Subject: Duke Energy Corporation  
Catawba Nuclear Station, Units 1 and 2  
Docket Numbers 50-413 and 50-414  
Request for Relief Number 03-001  
Reply to Request for Additional Information

REQUEST FOR ADDITIONAL INFORMATION

CATAWBA NUCLEAR STATION, UNITS 1 AND 2

The Nuclear Regulatory Commission (NRC) staff has reviewed the licensee's submittal dated May 22, 2003, requesting relief from performing volumetric examinations on the Catawba Nuclear Station (Catawba), Units 1 and 2, Regenerative Heat Exchangers as required by Section XI of the American Society of Mechanical Engineers (ASME) Boiler and Pressure Vessel Code (Code), 1989 Edition for the second 10-year interval inservice inspection (ISI) program. The NRC staff has identified the following information that is needed to enable the continuation of its review.

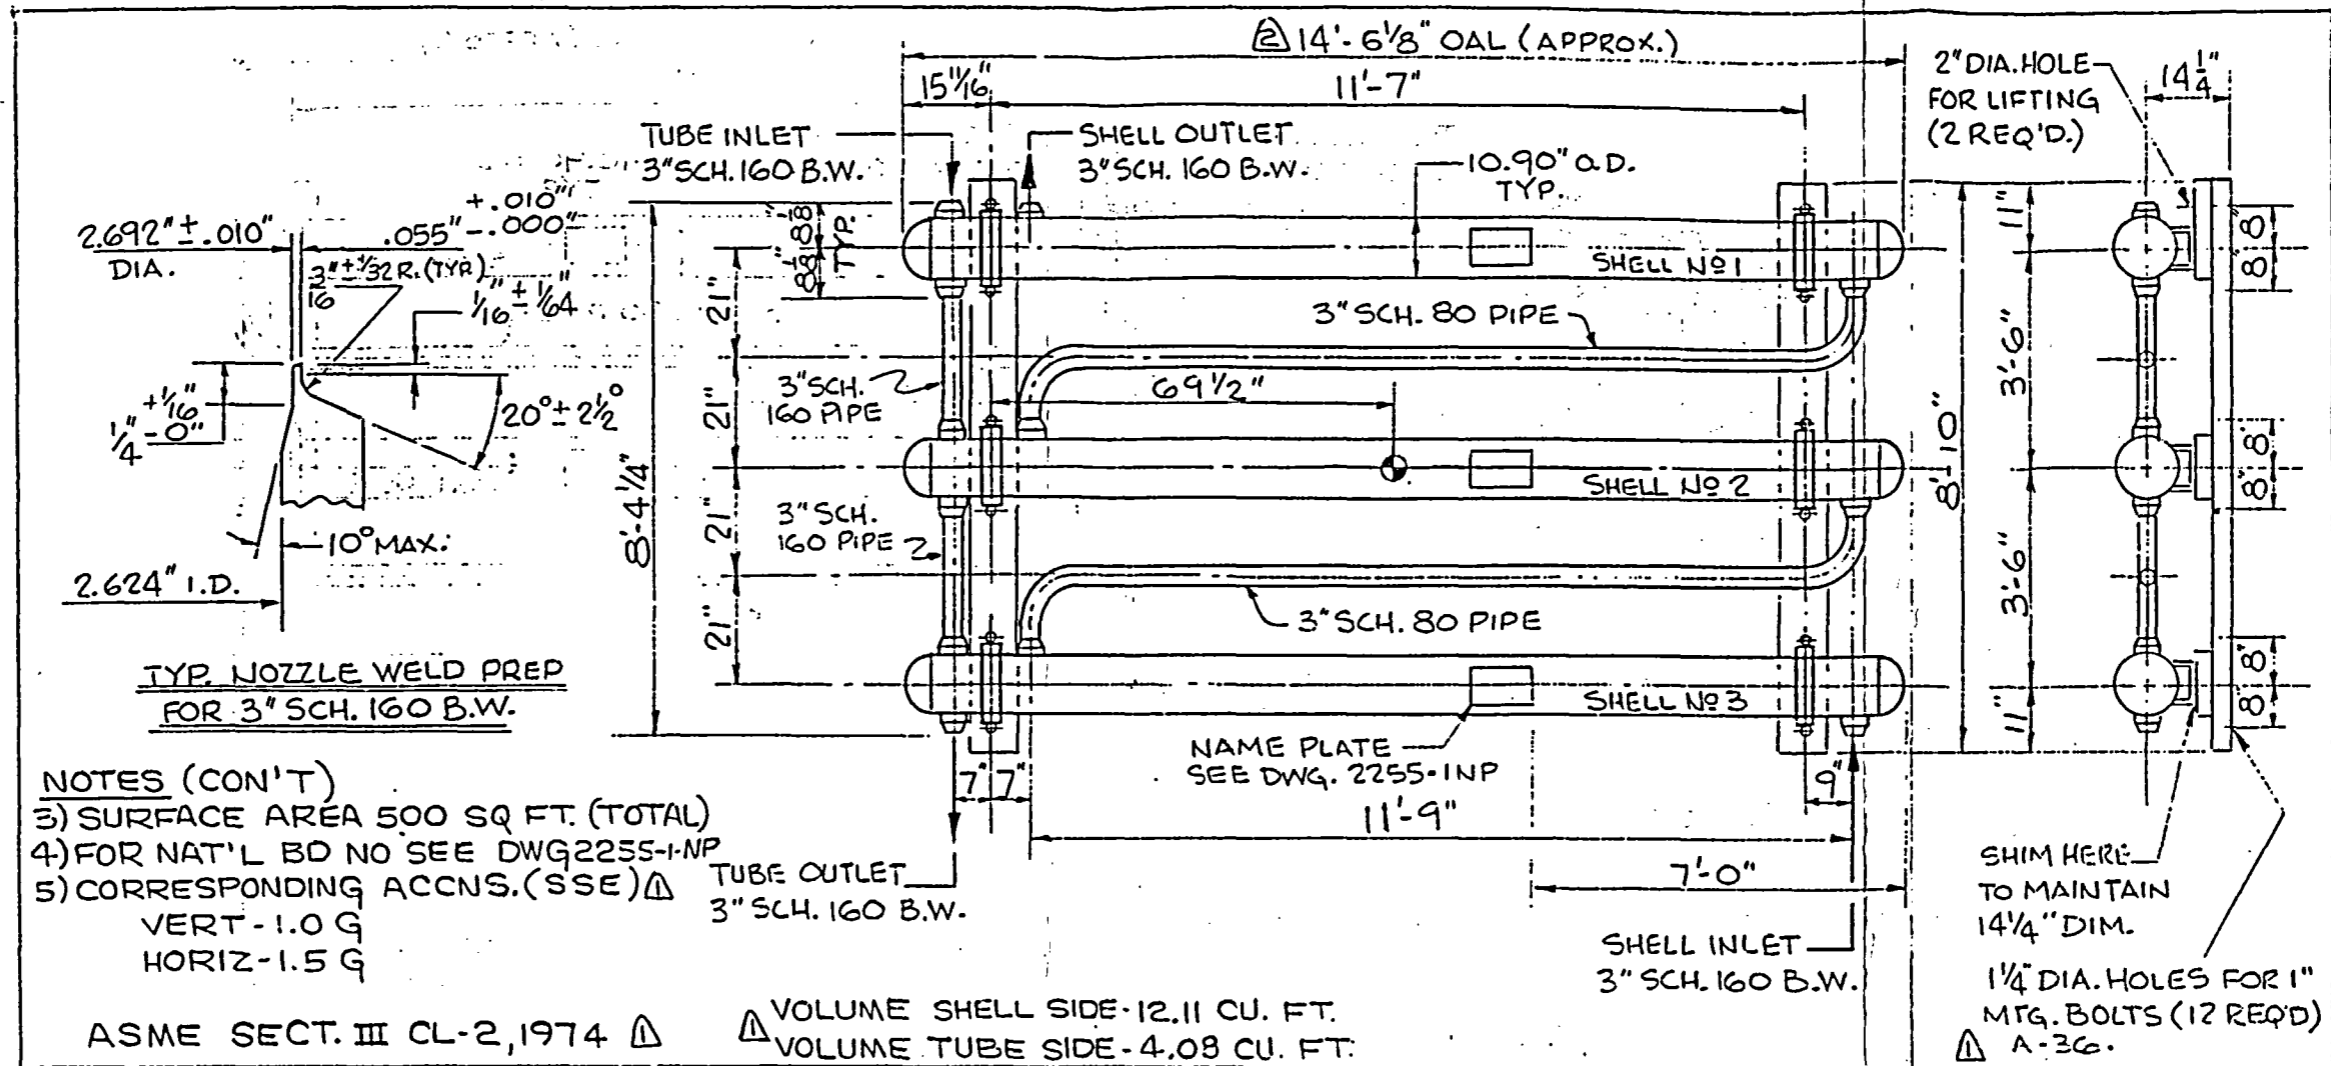
Additionally, typical Westinghouse designed plants have regenerative heat exchangers that are three horizontal tube and shell type vessels connected in series, stacked vertically. The drawings you provided only show one of the three vessels for each unit. Provide drawings or describe the actual configuration of the heat exchangers in their entirety, showing interconnecting piping and other appurtenances. Also provide more detailed drawings that show cross-sectional views of the head-to-shell and tubesheet-to-shell welds included in this request. The

drawings should list the materials' specifications, dimensions of the components, and clearly indicate interferences for performing ultrasonic and surface examinations. Include such drawings for the aforementioned nozzle-to-vessel welds, as applicable.

Furthermore, the ASME Code Table IWC-2500, Examination Category C-A, Note 3, states: "In the case of multiple vessels of similar design, size, and service (such as steam generators and heat exchangers), the required examinations may be limited to one vessel or distributed among the vessels." Discuss Duke's interpretation of Note 3, and more specifically, the pertinence of this note to regenerative heat exchanger welds at Catawba, Units 1 and 2.

Drawing No. 5581, Outline Drawing 3 Shell Regenerative Heat Exchanger

Duke Energy Corporation considers the three shell regenerative heat exchangers with the connecting piping, as shown on Joseph Oat and Sons, Incorporated outline drawing No. 5581, as one vessel; therefore, Note 3 does not apply. The regenerative heat exchanger is shown on the Catawba Nuclear Station Chemical and Volume Control System Flow Diagram Drawings as one piece of equipment.

**UNIT ASS'Y RQ-703**

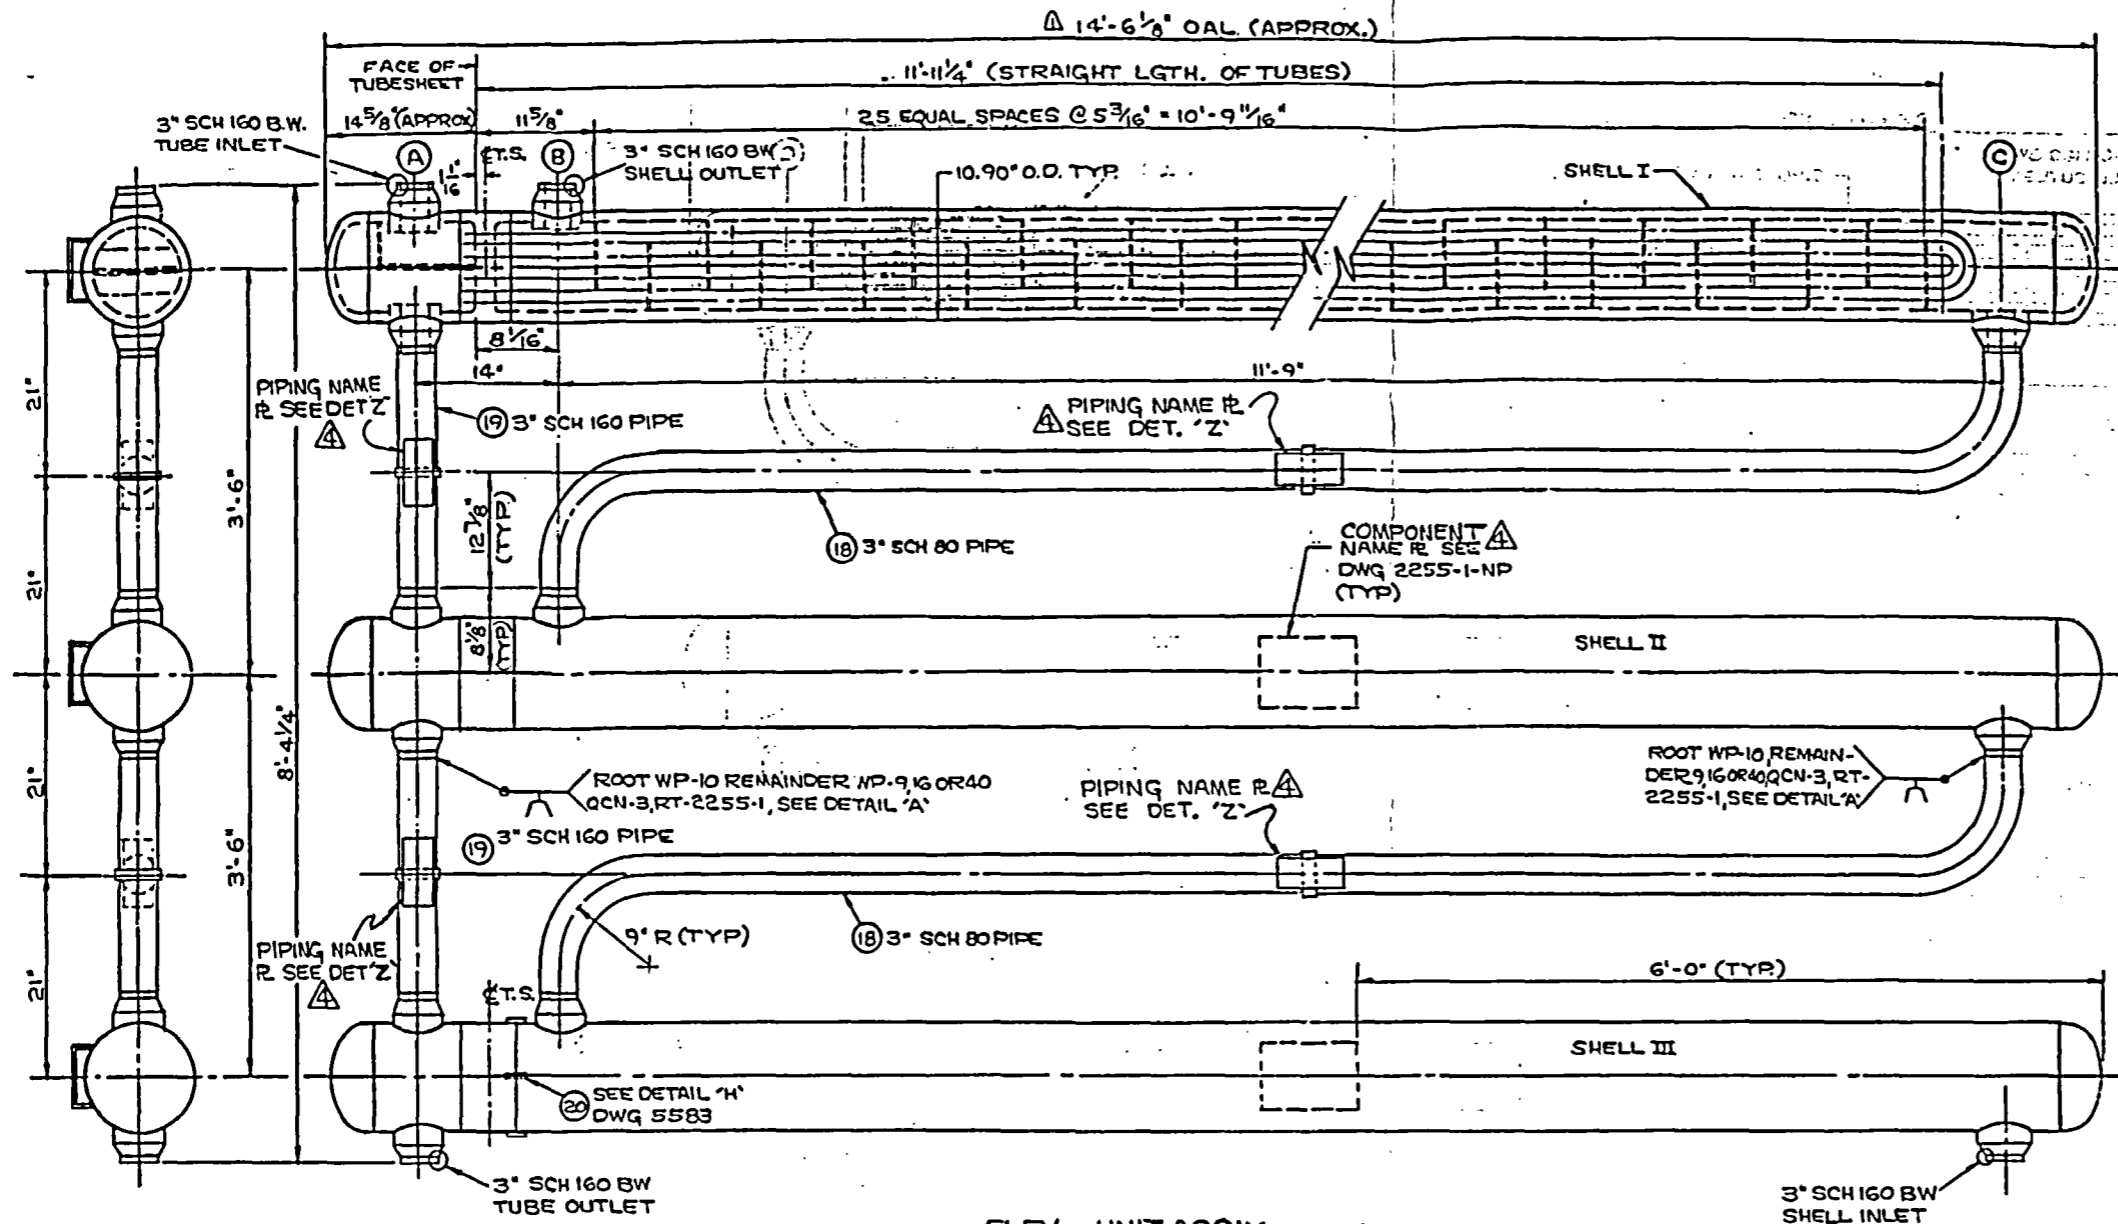
2. You requested relief from Examination Category C-A requirements for head-to-shell and tubesheet-to-shell welds on Catawba, Units 1 and 2, regenerative heat exchangers. The drawings you provided also show Class 2 nozzle-to-shell welds. Confirm that these nozzle-to-shell welds are exempt from volumetric and/or surface examination requirements per IWC-1222. If they are not exempt, provide information on any dose burden associated with the examination requirements for these welds.

ASME Section XI, Paragraph IWC-1222(b), applies to component connections nominal pipe size four inches and smaller (including nozzles, socket fittings, and other connections) in vessels, piping, pumps, valves, and other components. Chemical and Volume Control System piping welded to the Regenerative Heat Exchanger Nozzles is three inches in diameter. Therefore, these nozzle-to-shell welds are exempt from volumetric and/or surface examination requirements per IWC-1222.

Drawing No. 5582, Regenerative Heat Exchanger Unit Assembly RG-703
